IEEE802.3bt  
LLDP adhoc

Meeting #10: Tuesday September 5, 2017  
Rev001 (with meeting summary and action items)

- **The purpose** of this ad-hoc is to resolve LLDP state machine related comments from D2.4 and related issues for PSE and PDs prior sponsor ballot for D3.0.

## Annex A: Why we need $Y=A+B$ as currently in the spec? -2

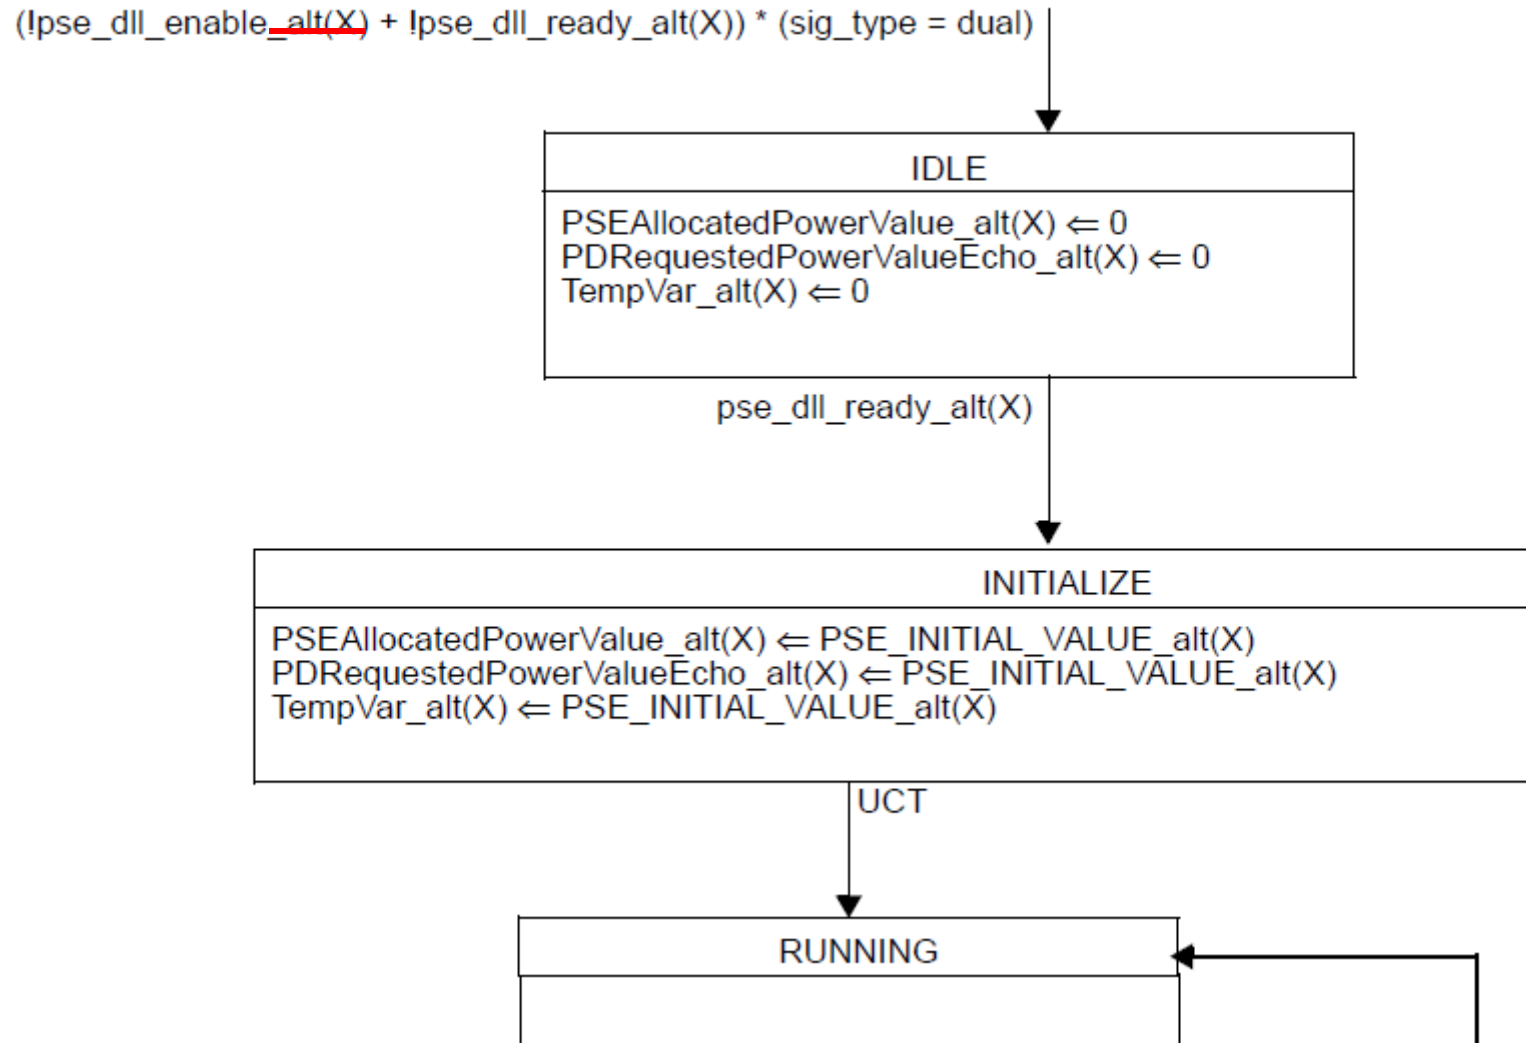
- Argument #3

High level power management care only for the total port power. The power management per pairset is kind of sublayer of the power management system. It is useful to pass the total power through the TLVs field. This is in general how current PSEs systems works.

Other alternative solution to this problem is to use the field “PSE max available power” which should be the total port power. We need to clarify in 79.3.2.6e that this value is applicable for PSE that supports single-signature and dual-signature.

# Annex B: Comment #297 D2.4 (Page 75 line 12 in D2.5) - Figure 145-43 Meeting #8: Group is OK

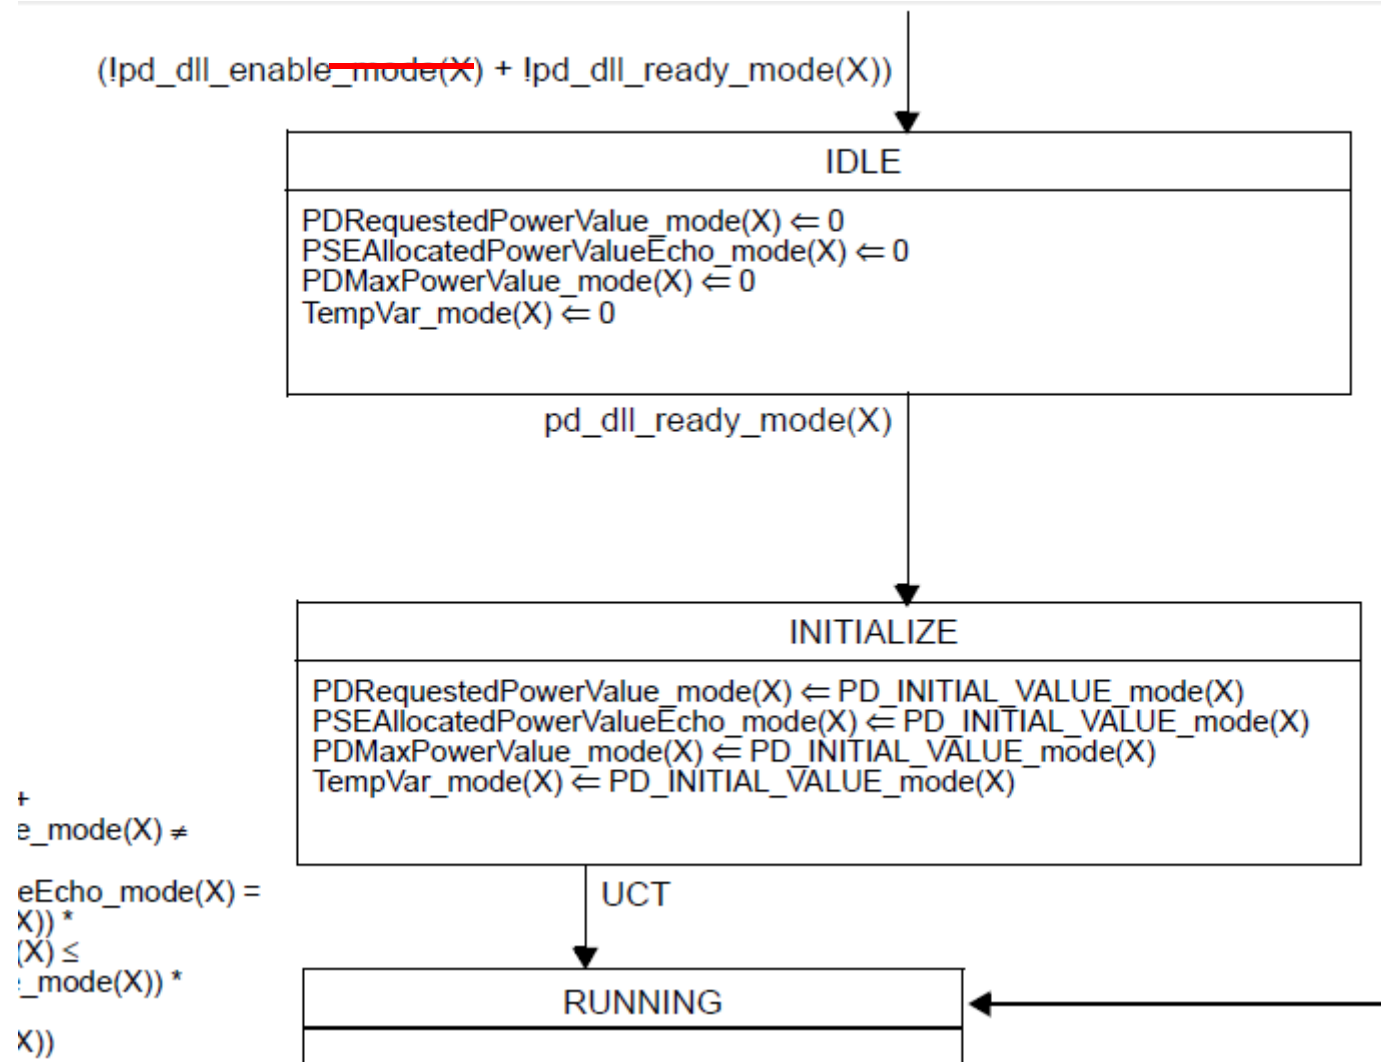
- Meeting #3: Group agrees to the proposed changes to PD DLL state machine Figure 145-43. [See Annex B for details](#) (Change `pd_dll_ready_mode(X)` to `pd_dll_ready` to resolve comment #297).

- Comment #297 D2.4 (D2.5 Page 78 line 46)

"If Mode (X) is non-active while the other mode is active, the inactive PD requested power value Mode (X) field value shall be set to 0."

- What is this trying to do ? The PD may wish to ask for power on an unpowered Mode...

Strike sentence.

- In Figure 145-44 and Figure 145-45 power control state diagrams when connected to dual-signature PD, we add in D2.3 an IDLE state in order to resolve non active Alternative(X) or no active mode(X) by setting the relevant variables to zero prior going to INITIALIZE state.
  - Figure 145-45: PSEAllocatedPowerValue\_alt(X), PDRequestedPowerValueEcho\_alt(X) and TempVar\_alt(X)
  - Figure 145-46: PDRequestedPowerValue\_mode(X), PSEAllocatedPowerValueEcho\_mode(X), PDMaxPowerValue\_mode(X) and TempVar\_mode(X)

- Yair it will work:
- The proposal is:
  - To change from `pd_dll_ready_mode(X)` to `pd_dll_ready` in the PD state machine.
  - To change “if this mode/Alt is inactive, set to value 0” to “if this Alt is inactive, set to value 0” i.e. keep this requirement only to PSE.

- Lennart response: The proposed response to this comment is to adopt:
  - To change from pd\_dll\_ready\_mode(X) to pd\_dll\_ready in the PD state machine.
  - To change “if this mode/Alt is inactive, set to value 0” to “if this Alt is inactive, set to value 0” i.e. keep this requirement only to PSE.
- **Group to discuss.**
- **GROUP OPINION? Group is OK.**
  - The modifications proposed to the state machine in Figure 145-43?
  - To change from pd\_dll\_ready\_mode(X) to pd\_dll\_ready in the PD state machine.
  - To change “if this mode/Alt is inactive, set to value 0” to “if this Alt is inactive, set to value 0” i.e. keep this requirement only to PSE.

# Annex I: Meeting #5: Comment #130, #293 D2.4 (D2.5 Page 74 line 11)

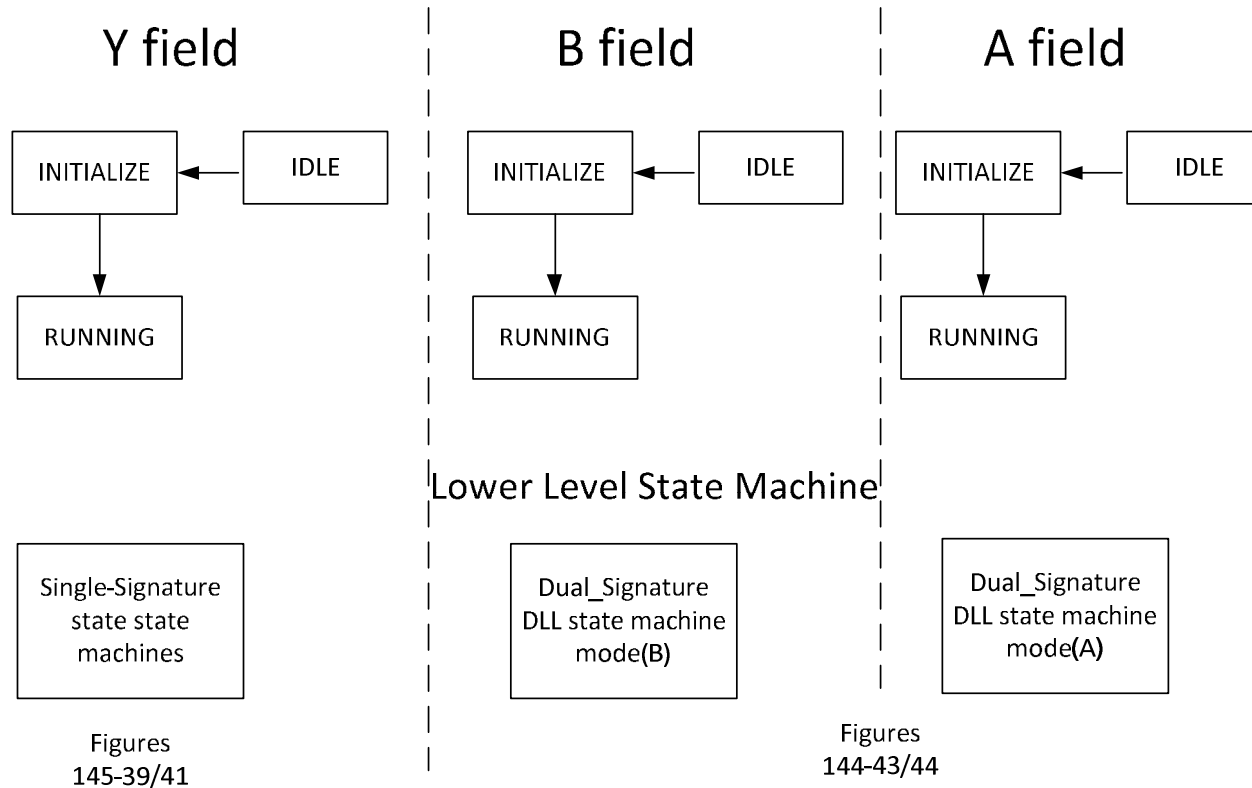
Added text, "Type 1 and Type 2 devices shall not support the Type 3 and Type 4 extension."  
Incorrectly blocks legacy types from using TLVs, Power status, System setup, PSE maximum available power, Autoclass, and Power done. The existing text does indicate what legacy Types are required to place in all Type 3 and Type 4 extension fields.

- **David Stover/Heath** : To move 4PID field to the legacy TLVs and not allow Type 1 and 2 devices to use the new TLVs.

**Lennart:** Implemented in the baseline.

**Group Agrees:** YES (and change the "shall" to "out of scope")
